Access Compliance Report

Public Rights-of-Way

(Curb Ramps)

Intersection ID: 10031994	Main Street: MONROE_RD	Cross Street: N/A	Location: SE
ADA ID: F4BF8B636AD5	Ramp Type: PerpDiag	Initial Pass/Fail: Fail	Overall Compliance: No
Codes/Mitigation Info/Possible Solution		Field Measurements/Component Compliance	
Severity Score: 22.5

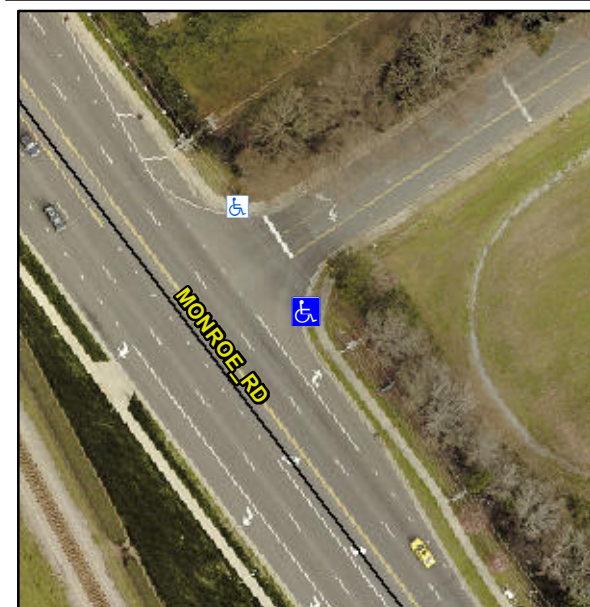
R304.5.1, R304.2.2, R304.5.3

Compliance	Description	Data	Compliance	Description	Data
N/A	Ramp Length (in)	48.0	No	Ramp Slope (%)	8.4
No	Ramp Width (in)	47.5	No	Ramp XSlope (%)	3.3
N/A	Flare Type LT	N/A	N/A	Flare Type RT	N/A
N/A	Flare Slope LT (%)	N/A	N/A	Flare Slope RT (%)	N/A
N/A	Flare Traversable LT?	N/A	N/A	Flare Traversable RT?	N/A
N/A	Landing Length (in)	N/A	N/A	DWS Provided?	N/A
N/A	Landing Width (in)	N/A	N/A	DWS Contrast?	N/A
N/A	Landing Slope (%)	N/A	N/A	DWS Length (in)	N/A
N/A	Landing X Slope (%)	N/A	N/A	DWS Full Width?	N/A
N/A	Landing Curb? (Y/N)	N/A	N/A	DWS Offset (in)	N/A
N/A	Shared Landing?	N/A			
N/A	Gutter Ponding?	N/A	N/A	Gutter Slope (%)	N/A
N/A	Gutter Lip Ht (in)	N/A	N/A	Gutter X Slope (%)	N/A
N/A	Painted X Walk1?	No	N/A	Painted X Walk2?	No
	X Walk 1 Direction	To SW		X Walk 2 Direction	To NW
N/A	X Walk 1 Width (in)	N/A	N/A	X Walk 2 Width (in)	N/A
	X Walk 1 Slope (%)	1.4		X Walk 2 Slope (%)	1.1
	X Walk 1 X Slope (%)	0.2		X Walk 2 X Slope (%)	2.2

Remove & Replace Curb Ramp With Two New Directional Ramps or Equivalent.
